REPORT OF
RETENTION POND STUDY

FANSTEEL, INC.

FANSTEEL RESPONSE TO:
REQUEST FOR ADDITIONAL INFORMATION

WASTE RETENTION POND

GROUND WATER CONTOUR MAP CONTOUR INTERVAL = 2 FEET

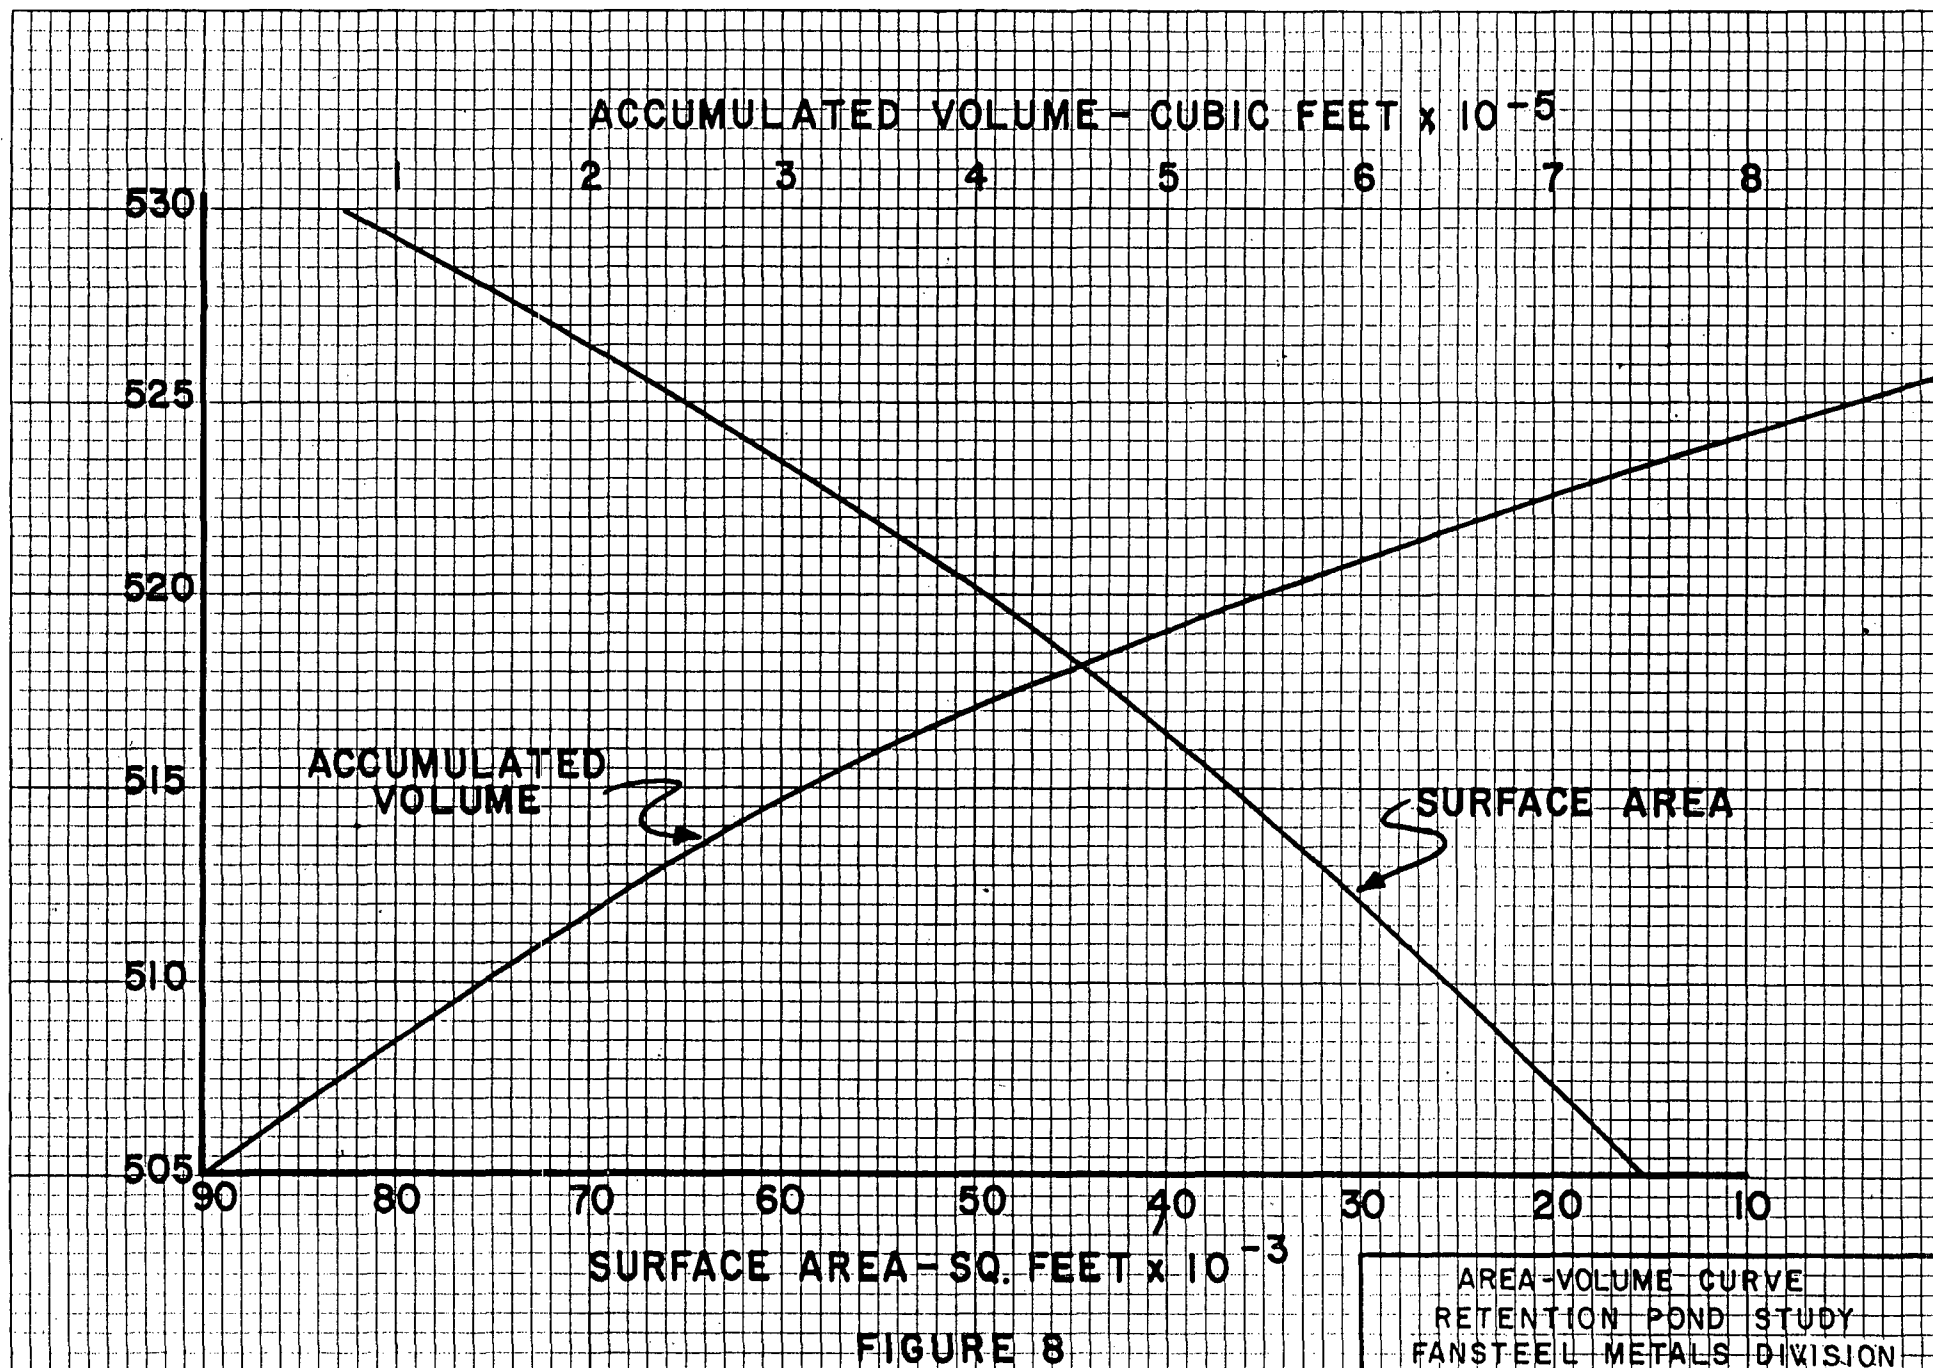
ITEM 3 Provide a Detailed Ground Water Contour Map of the Site Area. The Map Should Have Contour Intervals of Not More Than Five Feet and Should Indicate Expected Flow Paths From the Waste Retention Ponds to the Site Boundary or Nearest Downgradient Water Users.

The map is presented on the next page. The contour interval is two feet. Ground water flow is from the south and west to the east and the Arkansas River, and to the north to the flat plain.

The proposed pond is impervious with a liner. The pond will make no contribution to ground water.

The ground water contour map presented with our March, 1978 response was incorrectly drawn, based on inadequate data. In our September, 1978 response, we have presented a revised ground water contour map (see Item 3). The contours were drawn from data obtained over a three year period. The maximum fluctuation of four feet occurred in Well No. 4. Otherwise, very little fluctuation was observed.

The water mound indicated on the March, 1978 map is incorrect. This mound is eliminated on the September, 1978 map.

FIGURE 9

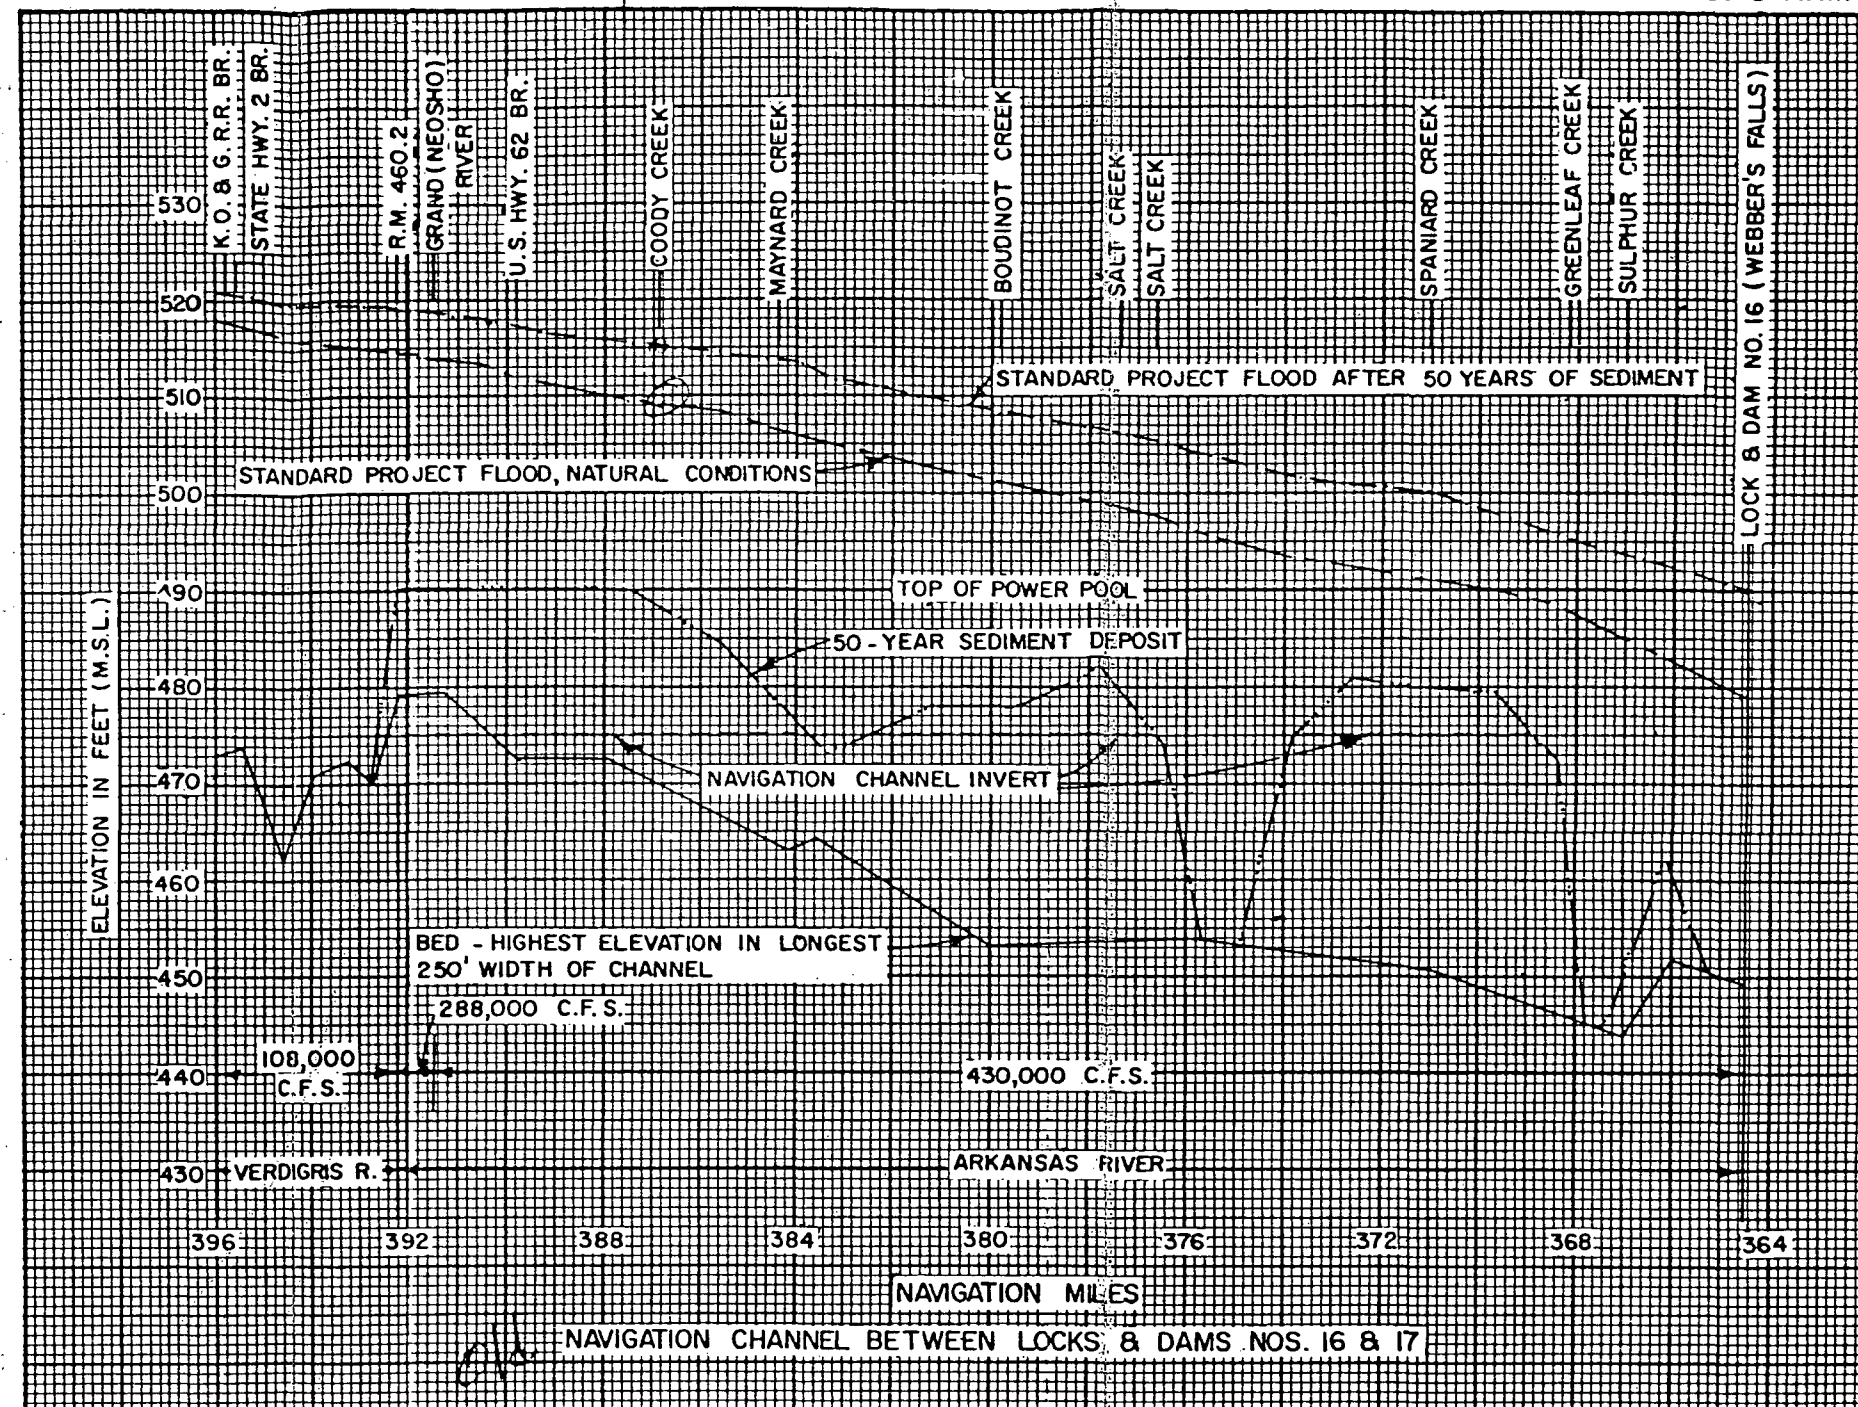
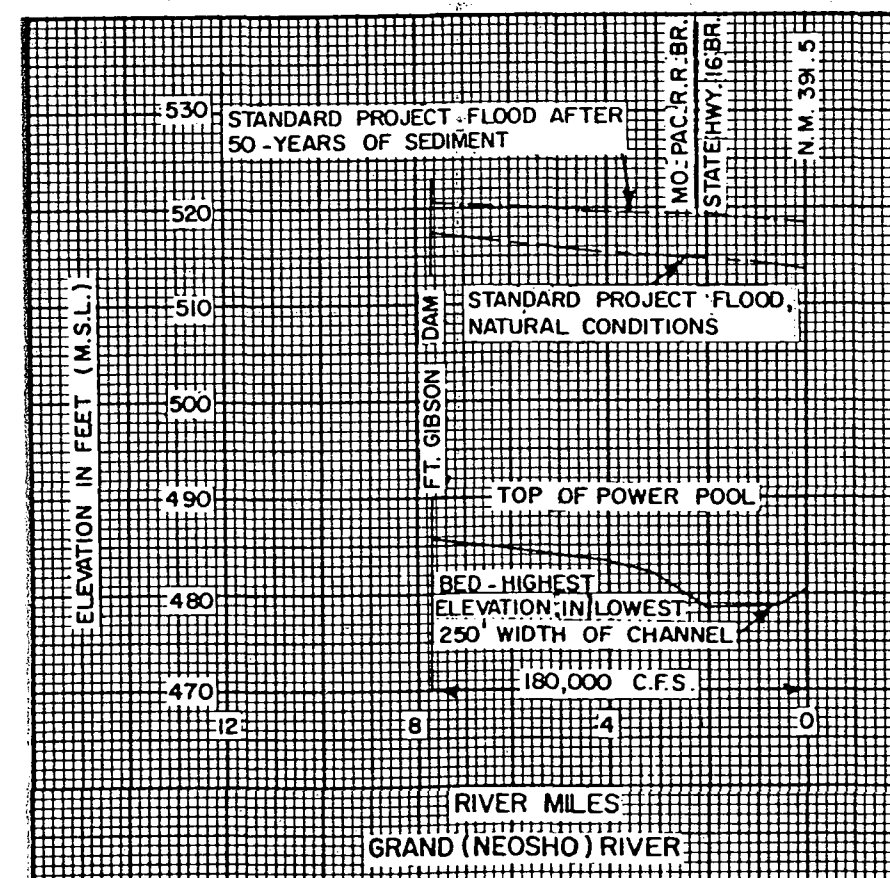
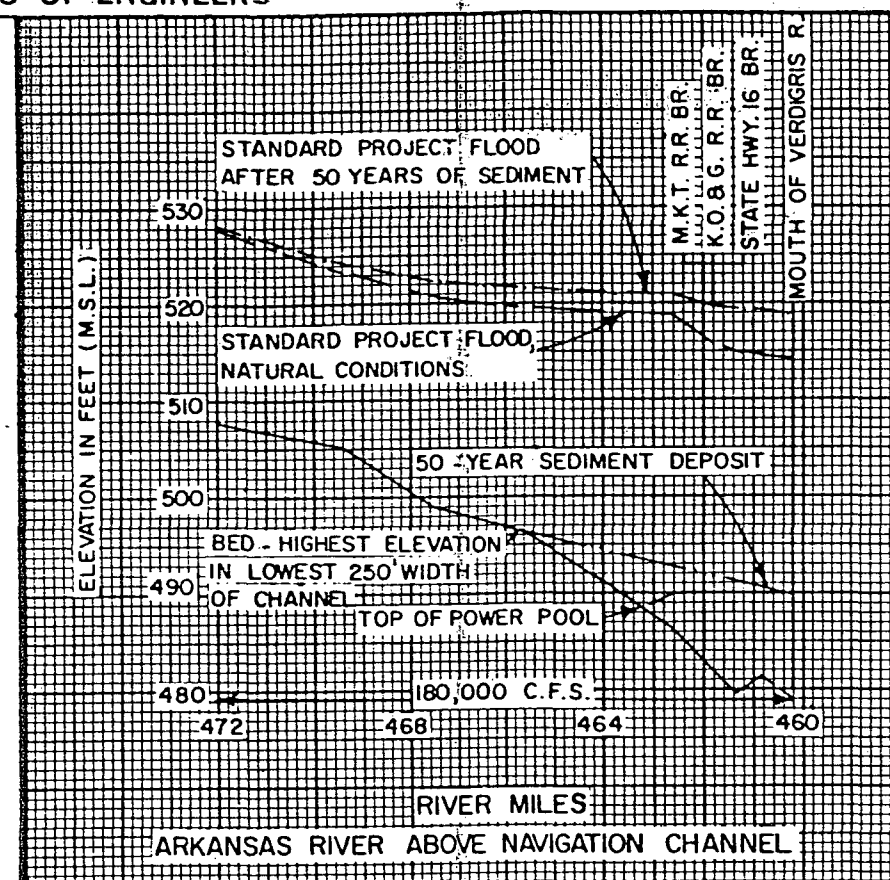
ITEM 7 Provide Analyses to Document That the Down-Stream Toe at the Dam Will Not Be Affected By Erosion Due to the Occurrence of Floods (as Severe as the Probable Maximum Flood) on Adjacent Streams (Such as Arkansas River or Any Minor Drainage Course Where Floods Could Affect the Toe of the Embankment). The Analyses Should Include: (a) PMF Estimates (Discharge), (b) Water Surface Profiles With Stream Cross-Sections at the site For Each Critical Stream, (c) Estimates of Velocities at the Embankment Toe, (d) Estimates of Repriced Erosion Protection With Design Bases For This Protection (When Applicable).

ITEM 371.17 Provide the Bases For Your Estimates of Probable Maximum Flood Elevation and Velocity. Provide the River Cross-Sections Used in Your Estimates. Document the Techniques Used In the Computations and Justify That They are Conservative (i.e., Lead to Higher Flood Levels and Velocities Than a More Realistic Approach) if They Cannot Be Shown to Be Realistic.

The greatest flood of record for the Arkansas River at Muskogee, Oklahoma is 400,000 cfs. During the design of the Webers Falls Dam, the U. S. Corps of Engineers, Tulsa office, took cross-sections of the Arkansas River and ran back water curves of different discharges. They selected 430,000 cfs as the flow during their "Standard Project Flood". A print out of the stream cross sections, and a print out of water surface elevations for the reach upstream and downstream of the plant site are presented. The plant is located about station 203 + 40. Here the water surface elevation is about 516.15 feet. This is about 17 feet below the crest of the dike.

There is an old ox bow lake across the river from the plant. When the river overflows its banks on the east side, the ox bow serves as a temporary reservoir. This results in a dramatic velocity check between stations 175 + 80 and 252 + 30. Based on these data, it is estimated that the river velocity near the proposed basin is less than 8 feet per second.

See Item 7, Fansteel response of September, 1978. The discharge and river cross-sections were obtained from the Tulsa office of the U. S. Corps of Engineers. These data are continually being refined and updated by the Corps. It is felt that these data are the most reliable that are available.

The water surface elevations and velocities were obtained from a computer solution to backwater curves for gradually varied flow.
